**APPENDIX E**  
**Estimation of Rock Mass Strength Properties and Evaluation of Rock Mass Structure**

**APPENDIX E.1**  
**WSDOT Memorandum Dated April 8, 2009**

SUBJECT: I-90 Snoqualmie Pass East – Hyak to Keechelus Dam  
Snowshed shaft foundations

## Snowshed Shaft Foundations: Rock Strength Estimates for DFSAP Analysis - I-90 Snoqualmie Pass East

Figure 4  
Bi-Planar Dip Slope Failure Mechanism

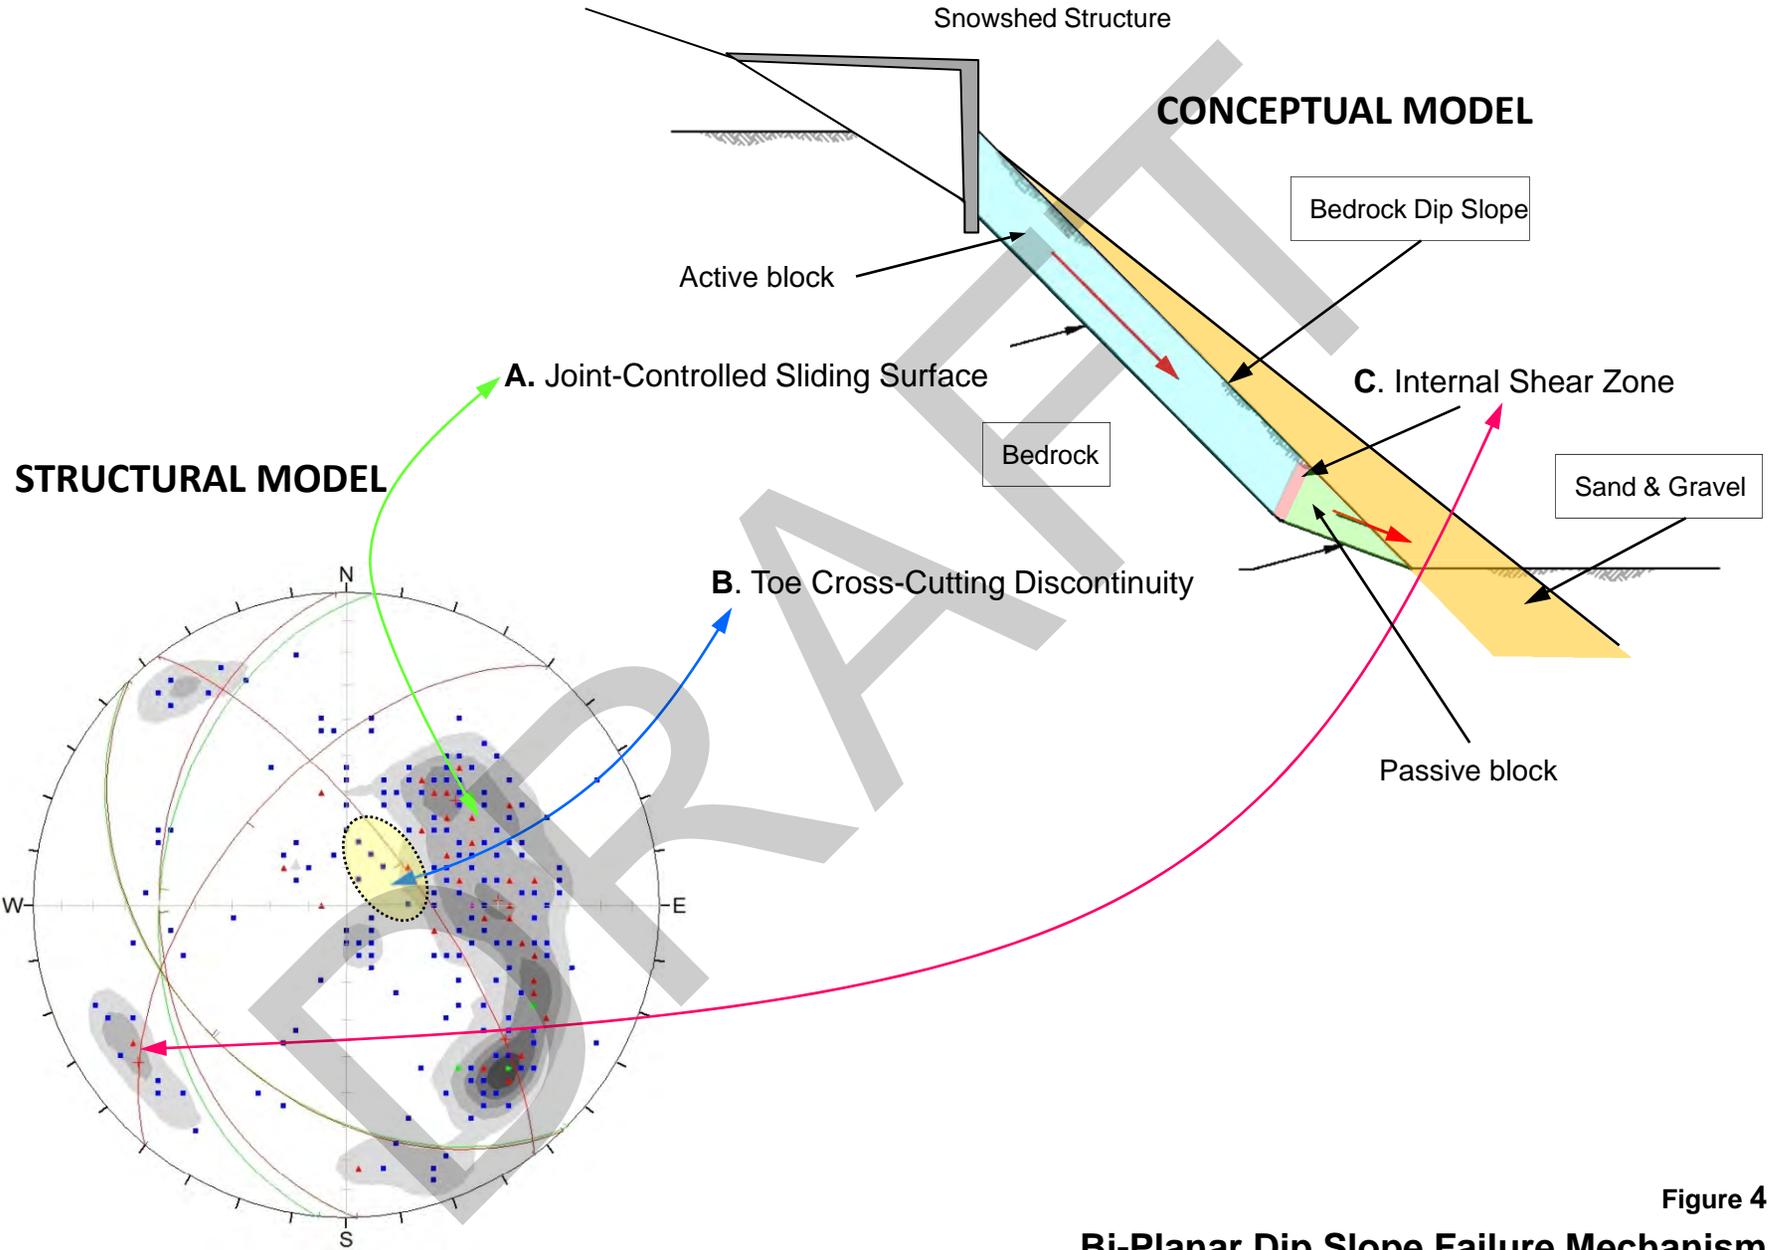
A potential hybrid failure mechanism that is consistent with the structural geology is referred to as the "**bi-planar**" model and is illustrated in the conceptual sketch shown on Figure 4. This mechanism is also referred to as the active-passive block model. Bi-planar failures require highly specific structural orientations and are relatively uncommon. The most favorable geologic regime is that of dip slopes formed by bedding in sedimentary rock types. The essential structural features for this mechanism are three-fold and include:

The correlation between these three prerequisites and the current structural model is shown in the lower part of Figure 4. Requisite "A" is fulfilled by Sets 1 and 1a. Requisite "C" is fulfilled by Set 2. However, there are very few televiewer-logged features that fulfill the requisite "B" cross-over feature.

It is concluded that the bi-planar is not viable for the SSD foundation slopes and that additional stability analyses to determine safety margins are not warranted.
